Council Meeting Agenda
November 24, 2025

Final Determination/Ordinance 2025-14 Carlisle Lane, LLC/Preliminary Major Subdivision

RE: Carlisle Lane, LLC – Preliminary Major Subdivision – Ordinance 2025-14
Planning Commission Recommendation

TRUITT TOWNHOMES

TYPICAL SECTION - LILAC LANE
PROPOSED SUBDIVISION STREET
NTS

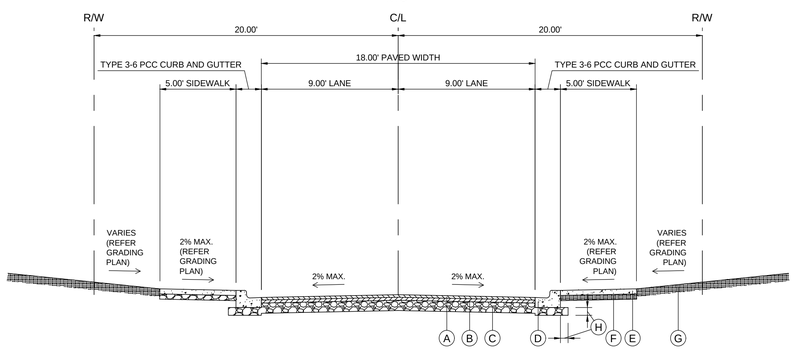
- Chapter 200-8(A)(14)(a) requires a pavement width of 36 feet for local residential streets with parking on both sides. The applicant is seeking permission to reduce the pavement width for Lilac Lane to 30 feet. **The Planning Commission recommended approval of the waiver request upon a vote of 3 to 2.**

- Chapter 200-8(A)(14)(a) requires a right-of-way width of 60 feet for local residential streets. The applicant is seeking permission to reduce the right-of-way width for Lilac Lane to 43.34 feet. **The Planning Commission recommended denial of the waiver request upon a vote of 4-1.**

On a 30’ paved width street, a 43.34’ ROW places the ROW line on the back edge of the proposed sidewalk, as shown on the plan. Beyond said line, a 15’ wide maintenance easement dedicated to the City of Milford is proposed.

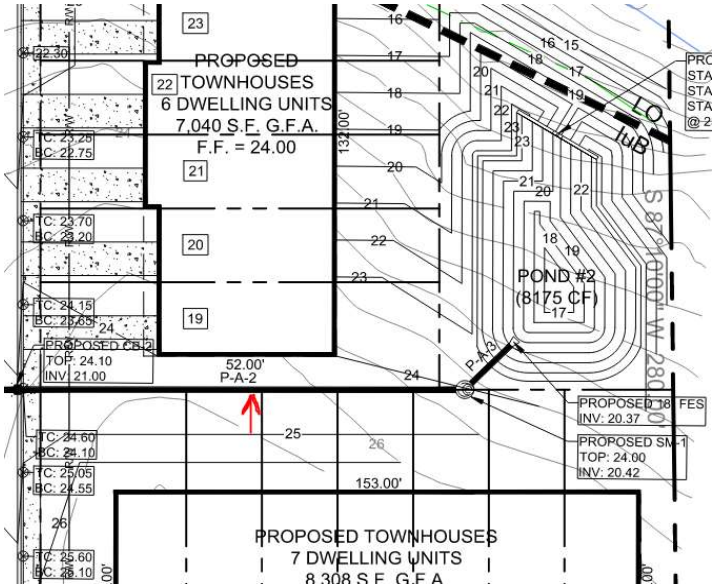
26. How will drainage in the rear yard areas be handled to minimize flooding issues on the residential lots? **Addressed.**
27. Contour 22 (see image below) stops abruptly. Revise the grading so the contours continue or tie-in to existing. **Addressed.**

28. The location below is showing the flow toward the building. Revise the grading so the flow is always away from the building. **Addressed.**

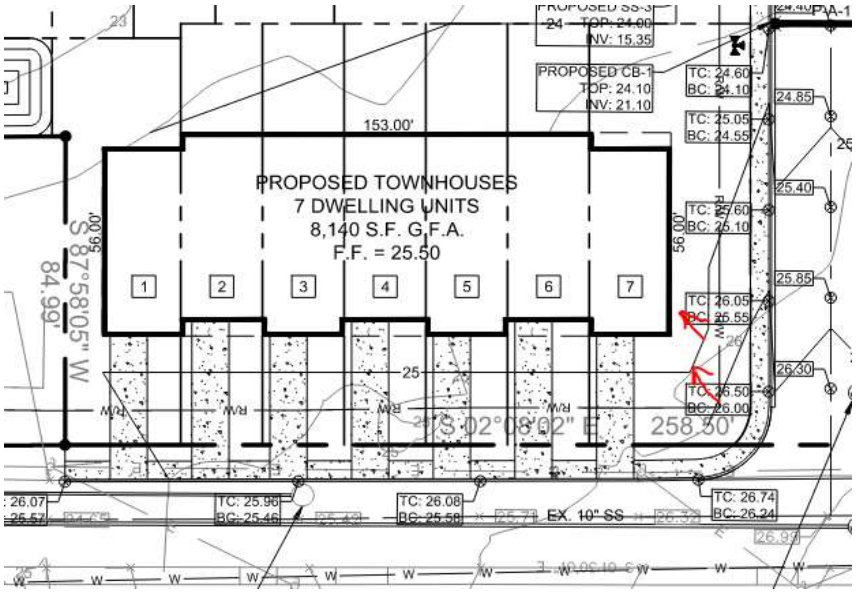
29. See the image below, grading is such that the flow is going toward the building. Revise the grading so the flow is away from the building. **Addressed.**

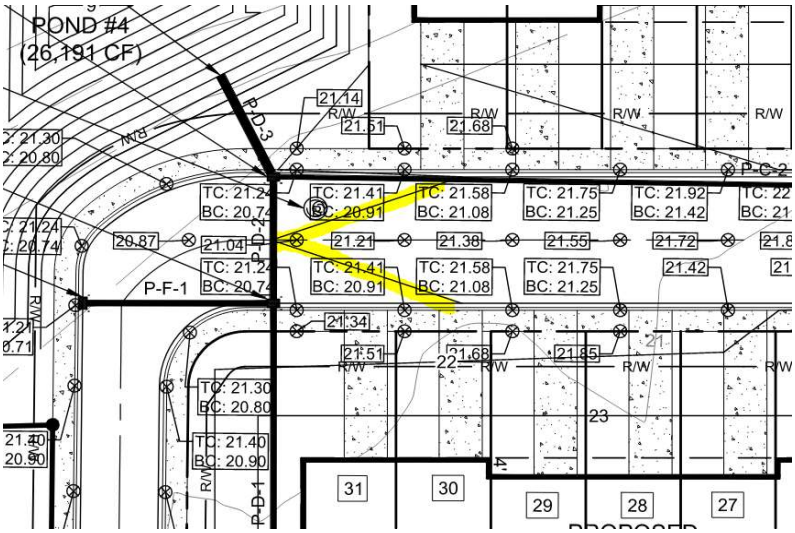
30. Currently, the 21 contour does not continue (see image below). **Addressed.**

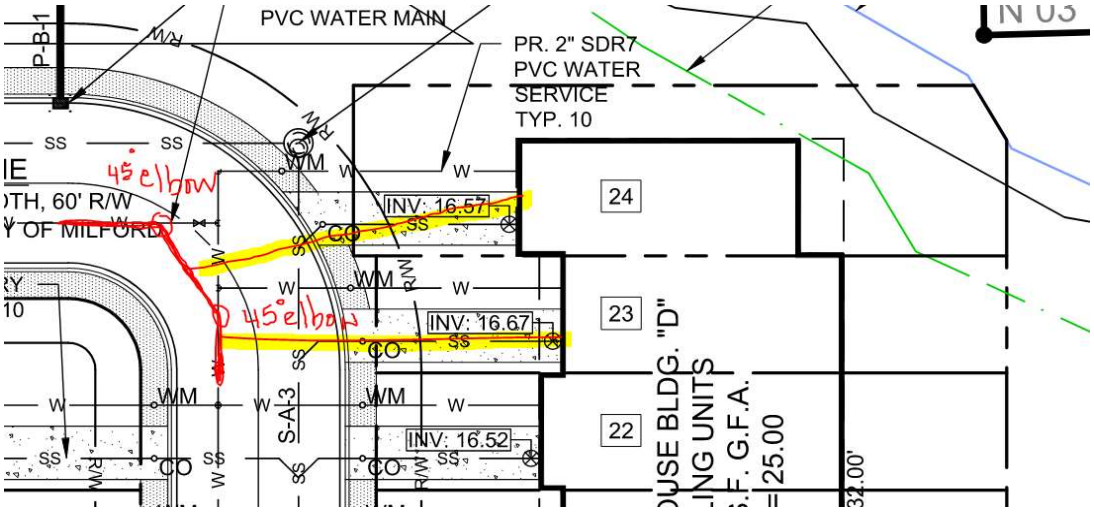
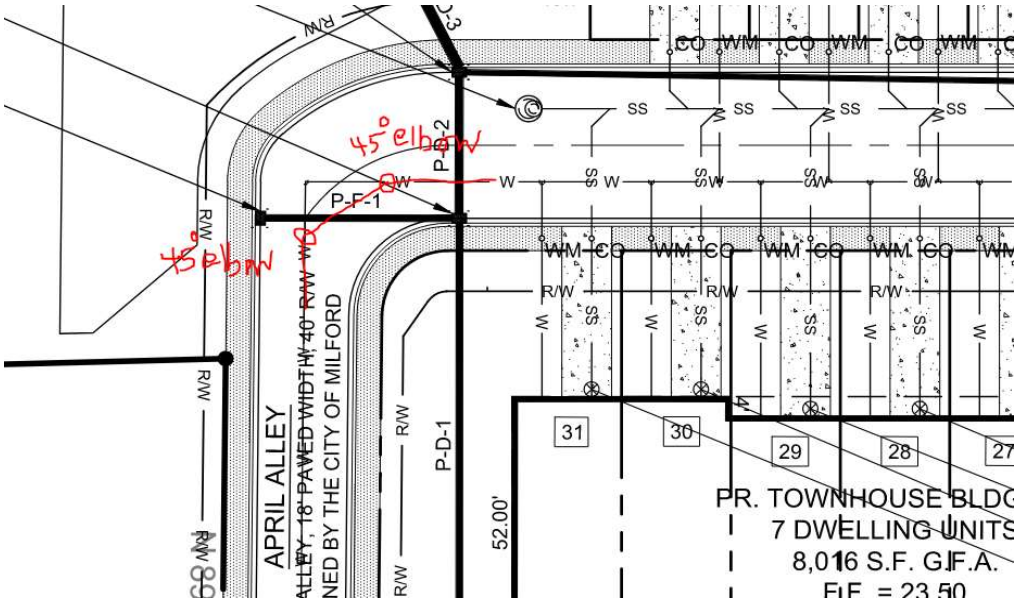
43. Specify the size and material of the sewer lateral in the plan. **Addressed.**
44. Provide the slope for all sanitary sewer laterals. In addition, provide the inverts for the laterals so the slopes can be verified. Sanitary sewer laterals shall not be less than 2%. **Addressed.**

45. For lots 1-14, water and sewer services shall come straight out into the street and connect to the existing main. A new parallel main or joint service line will not be permitted on private property as shown, revise accordingly. **Addressed.**
46. Loop the water line down the 18’ wide roadway and connect into Truitt Avenue. **Addressed.**
47. Provide a cross-section for the 18’ wide roadway. **Addressed.**
48. Label the duplex residual lot on Truitt Avenue and show the water and sewer services to the property. **Addressed.**
49. Currently, the water main is shown to be very close to sanitary sewer manhole SS-2. Revise the plans so the water main is at least 10’ from the sanitary sewer line. **Addressed.**
50. Provide isolation valves at the Tee at the junction of Truitt Ave. and Lilac Lane. Comment Remains. See the image below for water main layout. **Addressed.**
